TSP-3

MD 214 (Central Avenue) and Addison Road

SIGNALIZATION PLAN

1 REDLINE REVISION NO. 1
PEDESTRIAN POLE RELOCATION
SEPTEMBER 15, 2008
BRD NML SDY

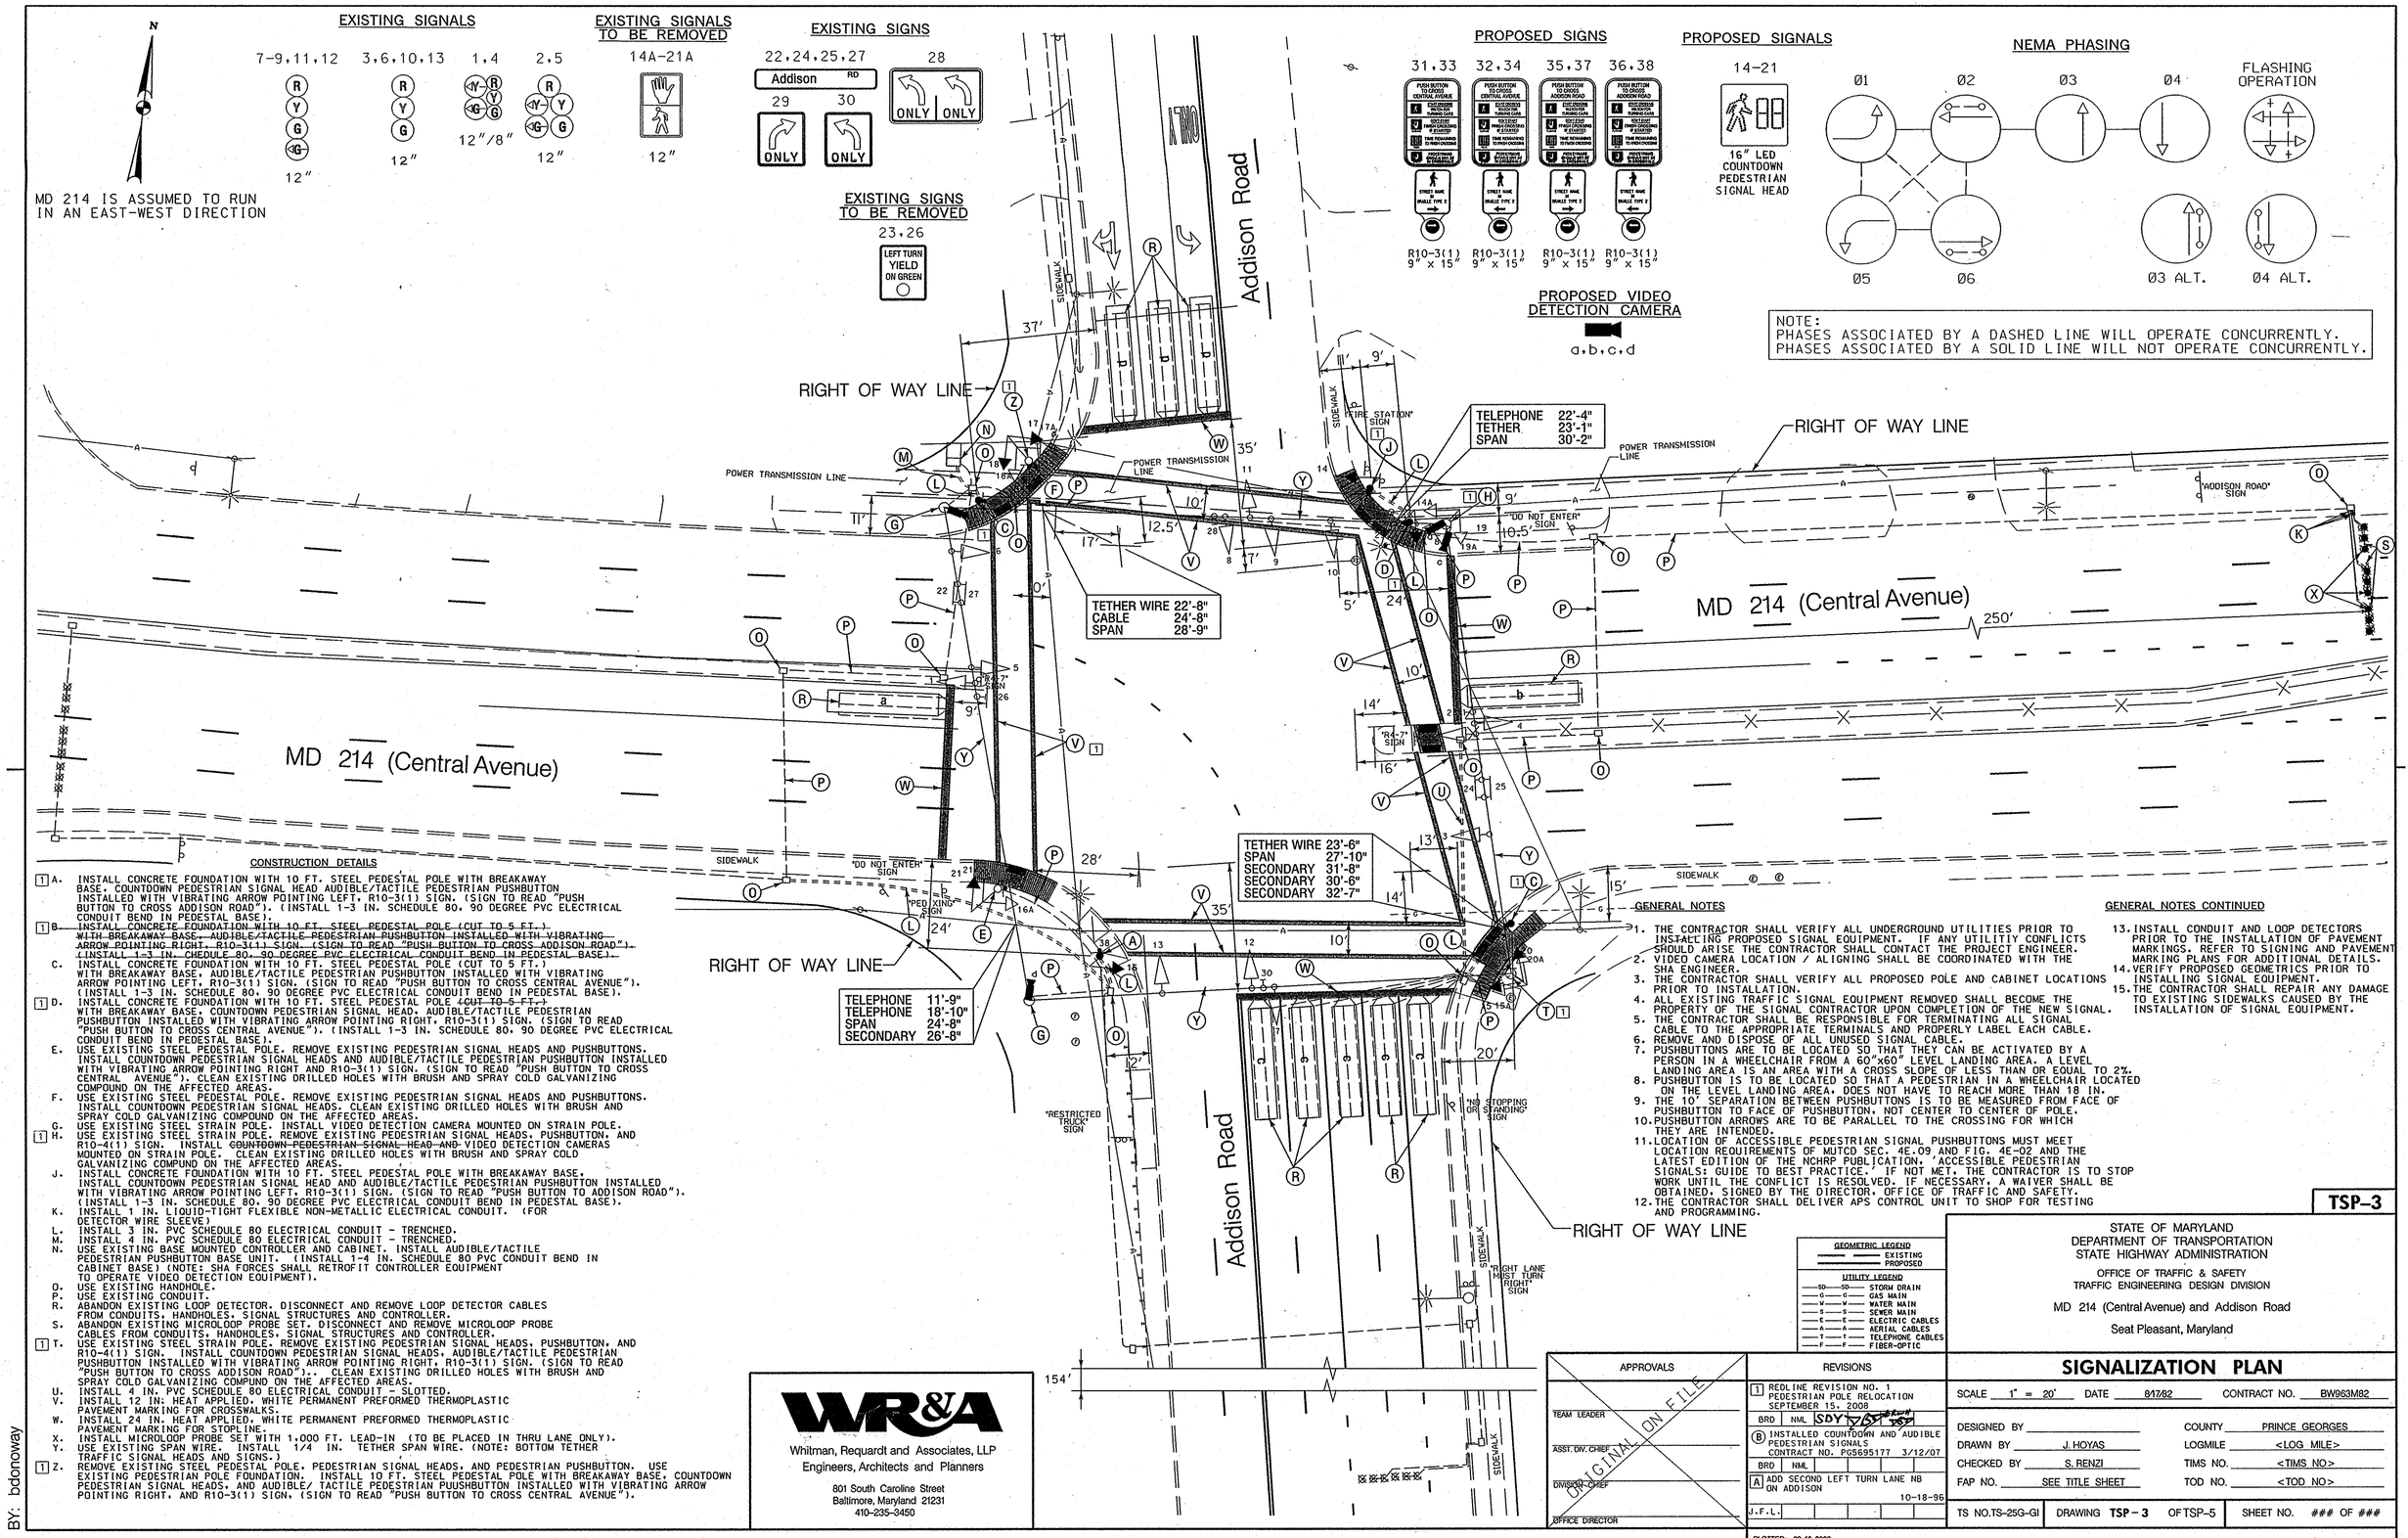
1 A. INSTALL CONCRETE FOUNDATION WITH 10 FT. STEEL PEDESTAL POLE WITH BREAKAWAY BASE. COUNTDOWN PEDESTRIAN SIGNAL HEAD AUDIBLE/TACTILE PEDESTRIAN PUSHBUTTON INSTALLED WITH VIBRATING ARROW POINTING LEFT. R10-3(1) SIGN. (SIGN TO READ "PUSH BUTTON TO CROSS ADDISON ROAD"). (INSTALL 1-3 IN. SCHEDULE 80. 90 DEGREE PVC ELECTRICAL CONDUIT BEND IN PEDESTAL BASE).

1 B. ~~INSTALL CONCRETE FOUNDATION WITH 10 FT. STEEL PEDESTAL POLE (CUT TO 5 FT.) WITH BREAKAWAY BASE. AUDIBLE/TACTILE PEDESTRIAN PUSHBUTTON INSTALLED WITH VIBRATING ARROW POINTING RIGHT. R10-3(1) SIGN. (SIGN TO READ "PUSH BUTTON TO CROSS ADDISON ROAD"). (INSTALL 1-3 IN. CHEDULE 80. 90 DEGREE PVC ELECTRICAL CONDUIT BEND IN PEDESTAL BASE).~~

1 D. INSTALL CONCRETE FOUNDATION WITH 10 FT. STEEL PEDESTAL POLE ~~(CUT TO 5 FT.)~~ WITH BREAKAWAY BASE. COUNTDOWN PEDESTRIAN SIGNAL HEAD. AUDIBLE/TACTILE PEDESTRIAN PUSHBUTTON INSTALLED WITH VIBRATING ARROW POINTING RIGHT. R10-3(1) SIGN. (SIGN TO READ "PUSH BUTTON TO CROSS CENTRAL AVENUE"). (INSTALL 1-3 IN. SCHEDULE 80. 90 DEGREE PVC ELECTRICAL CONDUIT BEND IN PEDESTAL BASE).

1 H. USE EXISTING STEEL STRAIN POLE. REMOVE EXISTING PEDESTRIAN SIGNAL HEADS. PUSHBUTTON. AND R10-4(1) SIGN. INSTALL ~~COUNTDOWN PEDESTRIAN SIGNAL HEAD AND~~ VIDEO DETECTION CAMERAS MOUNTED ON STRAIN POLE. CLEAN EXISTING DRILLED HOLES WITH BRUSH AND SPRAY COLD GALVANIZING COMPUND ON THE AFFECTED AREAS.

1 T. USE EXISTING STEEL STRAIN POLE. REMOVE EXISTING PEDESTRIAN SIGNAL HEADS. PUSHBUTTON. AND R10-4(1) SIGN. INSTALL COUNTDOWN PEDESTRIAN SIGNAL HEADS. AUDIBLE/TACTILE PEDESTRIAN PUSHBUTTON INSTALLED WITH VIBRATING ARROW POINTING RIGHT. R10-3(1) SIGN. (SIGN TO READ "PUSH BUTTON TO CROSS ADDISON ROAD"). CLEAN EXISTING DRILLED HOLES WITH BRUSH AND SPRAY COLD GALVANIZING COMPUND ON THE AFFECTED AREAS.

1 Z. REMOVE EXISTING STEEL PEDESTAL POLE. PEDESTRIAN SIGNAL HEADS. AND PEDESTRIAN PUSHBUTTON. USE EXISTING PEDESTRIAN POLE FOUNDATION. INSTALL 10 FT. STEEL PEDESTAL POLE WITH BREAKAWAY BASE. COUNTDOWN PEDESTRIAN SIGNAL HEADS. AND AUDIBLE/ TACTILE PEDESTRIAN PUUSHBUTTON INSTALLED WITH VIBRATING ARROW POINTING RIGHT. AND R10-3(1) SIGN. (SIGN TO READ "PUSH BUTTON TO CROSS CENTRAL AVENUE").
